South Texas Project
Units 3 and 4
Docket Nos. 52-012 and 52-013
Impact of the Redesigned Ultimate Heat Sink on STP 3 & 4 COLA Review

**South Texas Project Units 3 & 4
Impact of the Ultimate Heat Sink Redesign
on χ/Q and Flooding Analyses**

Report SL-ER-2008-0001

Attachment A – Docketed STP Units 3 & 4 UHS Design (As described in COLA, Revision 1)

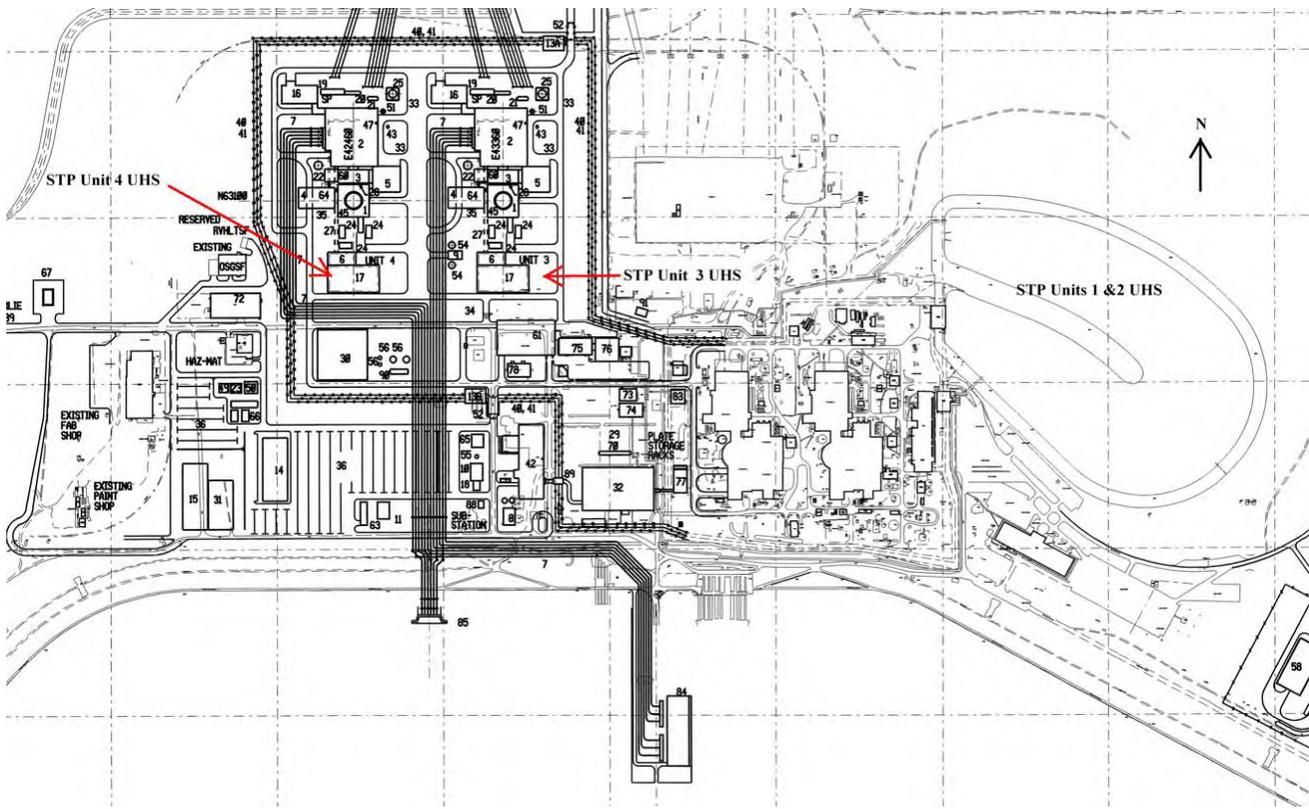
Section 9.2.5 of Revision 1 of the STP Units 3 & 4 FSAR [Reference 6.1] provides the conceptual design information for the previously considered UHS. Attachment A to this report shows the location of the STP Units 3 & 4 UHSs proposed at that time. This UHS water storage basin was to be a common structure for both the STP Units 3 & 4. The basin had a dividing wall, creating a dedicated compartment for each unit. Thus, the inventory was not shared between STP Units 3 & 4.

The UHS water storage basin was to be a Seismic Category I cylindrical structure (106.7-meter internal diameter and 17.1-meter-tall with 1.52-meter-thick wall) built partially below grade and sized for a water volume sufficient to meet the cooling requirements for 30 days following a design basis accident (DBA) with no makeup water and without exceeding the design basis temperature and chemistry limits. The docketed (as described in COLA, Revision 1) UHS basin was to be split by a 1.22-meter-thick divider wall into two symmetric compartments, one compartment dedicated to each unit.

Attachment B – Conceptual STP Units 3 & 4 UHS Redesign (Figure B-1 Site Layout)

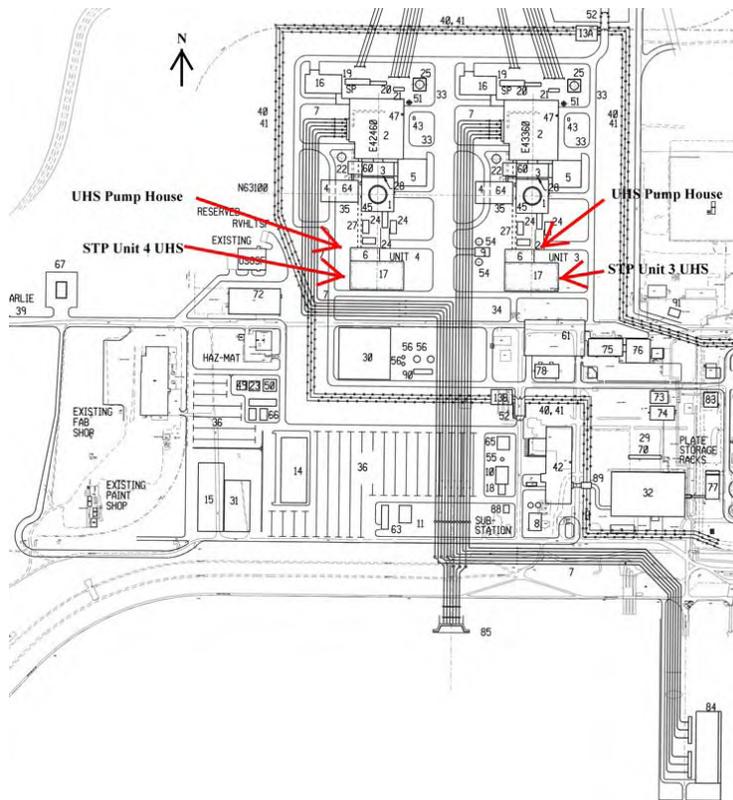
The redesign of the STP Units 3 & 4 UHSs proposes two separate, stand alone structures. Attachment B shows the layout and dimensions of the proposed STP Units 3 & 4 UHSs and adjacent RSW Pump Houses. The original single cylindrical STP Units 3 & 4 UHS structure, which was northwest of STP Unit 4, has been changed to two rectangular structures that are to be located south of the Reactor Buildings for each unit. Each unit's UHS will consist of a single 100 percent water basin that will have at least a 30 day supply of water to cope with an accident (LOCA) without credit taken for make-up.
